TOLEDO - LUCAS COUNTY PLAN COMMISSIONS

REF: SUP25-0021

SUBJECT: Special Use Permit for a new Community Center at 2405 Stickney Avenue

SITE PLAN

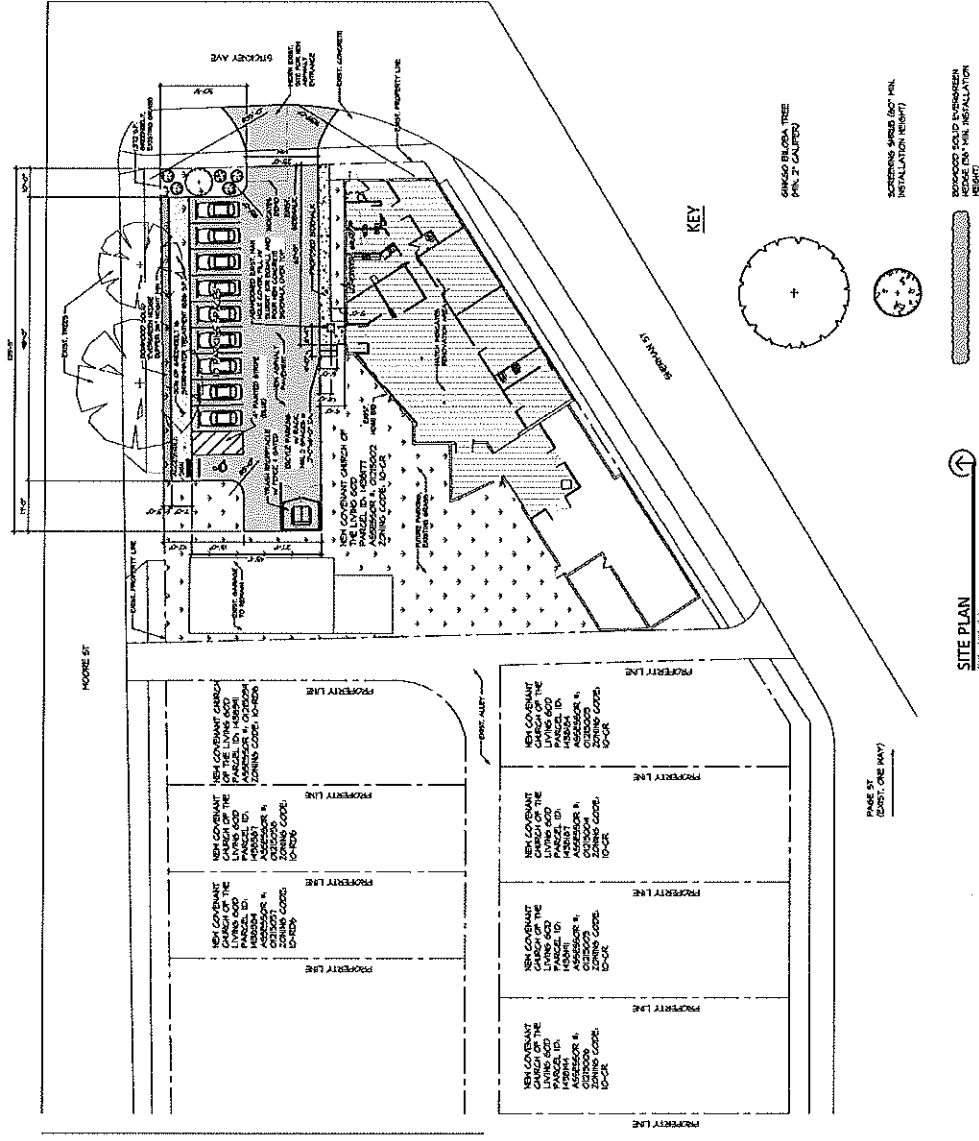
Off-street parking is not currently provided on this site. The applicant is proposing a small parking lot with ten (10) parking spaces at the corner of Stickney Avenue and Moore Street. The Plan Director has determined that this is an acceptable number of parking spaces per TMC§1107.0600 *Off-Street Parking Schedule "D"*. Due to the currently-proposed M-18-24, a Modification to TMC Chapter 11 – Zoning and Planning Code – Eliminating Parking Minimums, the applicant wishes to retain an option to not construct this proposed parking lot. If they wish to not construct the parking lot, they would be able to apply for a minor amendment to this special use permit to remove the parking portions of this approval.

TMC§1107.1700 requires one (1) of the proposed parking spaces to be van accessible in accordance with the Americans with Disabilities Act. This van-accessible space is shown; however, accessible parking must be located to provide the shortest path of travel to the building's accessible entrance. As such, the van-accessible space must be moved so that it is the closest parking space to the entrance. This requirement has been included as a condition of approval.

TMC§1107.0900 *Bicycle Parking* requires that this site provide two (2) bicycle parking spaces. These spaces have been shown and their location is acceptable as depicted. The proposed bicycle rack must be securely fixed to the ground and meet the standards of TMC§1107.0902.

TMC§1107.1202 *Setbacks* requires the proposed parking lot to be set back at least fifteen feet (15') from Moore Street and Stickney Avenue. The parking lots are currently set back ten feet (10') from Moore St and Stickney Ave. This is discussed in more detail below.

TMC§1108.0202 *Frontage Greenbelt* requires a fifteen foot (15') wide frontage greenbelt along both Moore Street and Stickney Avenue. The site plan depicts ten foot (10') wide frontage greenbelts along Moore Street and Stickney Avenue. The proposed parking lot will need to be shifted five feet (5') south and five feet (5') west to accommodate the required fifteen foot (15') wide frontage greenbelt. This should not be difficult as there are grass areas with a minimum dimension of five feet (5') in both of these directions, although the proposed sidewalk on the southern end of the parking lot will become flush with the building. This has been included as a condition of approval.

TMC§1108.0202 *Frontage Greenbelt* also requires at least one (1) tree for every thirty feet (30') of frontage and a solid evergreen hedge planting within the Moore Street and Stickney Avenue frontage greenbelts. Sufficient evergreen screening has been provided; however, only one (1) new tree planting is proposed. An additional four (4) trees are required within the Moore Street greenbelt and two (2) trees are required within the Stickney Avenue greenbelt. The existing trees identified on the plan are within the right-of-way and – as stated in TMC§1108.0202(A) – may not be used towards frontage greenbelt requirements. The inclusion of these additional trees on a revised landscape plan has been included as a condition of approval.

Lastly for TMC§1108.0202 *Frontage Greenbelt*, stormwater treatment facilities may occupy up to fifty percent (50%) of the frontage greenbelt. The proposed stormwater treatment swale appears to occupy more than fifty percent (50%) of the Moore Street greenbelt. Staff believes the required increase in greenbelt width will bring the stormwater treatment swale's occupation of the greenbelt below fifty percent (50%). Even so, the assurance that the stormwater treatment swale occupies no more than fifty percent (50%) of the greenbelt has been included as a condition of approval.

TMC§1108.0204 *Parking Lot Landscaping* requires two (2) canopy trees and six (6) shrubs for every ten (10) parking spaces within parking lots. As such, two (2) canopy trees and six (6) shrubs are required for the parking lot's interior landscaping. The depiction of these additional trees on a revised landscape plan has been included as a condition of approval.

18. Bicycle parking spaces shall meet the standards of TMC§1107.0902. **Pole/rack details shall be submitted to the Planning Director.**
19. Pursuant to TMC§§ 1107.1202 & 1108.0202 the proposed parking area shall be shifted to ensure a fifteen-foot (15') setback and frontage greenbelt on both Moore Street and Stickney Avenue. **Not acceptable as depicted. A revised site and landscape plan shall be submitted to the Plan Director depicting the required parking lot setback.**

20. Pursuant to TMC§1108.0202 the frontage greenbelts along Moore Street and Stickney Avenue require at least one (1) tree for every thirty feet (30') of frontage. **Not acceptable as depicted. A revised landscape plan shall be submitted to the Plan Director depicting a minimum of four (4) trees within the Moore Street greenbelt and two (2) trees within the Stickney Avenue greenbelt.**

21. Pursuant to TMC§1108.0202 stormwater treatment facilities may occupy up to fifty percent (50%) of each frontage greenbelt. **Not acceptable as depicted. A revised landscape plan shall be submitted to the Plan Director depicting the stormwater treatment facilities less than fifty percent (50%) of each frontage greenbelt.**

22. Pursuant to TMC§1108.0204 two (2) canopy trees and six (6) shrubs are required within parking lots for every ten (10) parking spaces. **Not acceptable as depicted. A revised landscaping plan shall be submitted to the Plan Director depicting a minimum of two (2) trees and six (6) shrubs within or immediately adjacent to the proposed parking lot.**
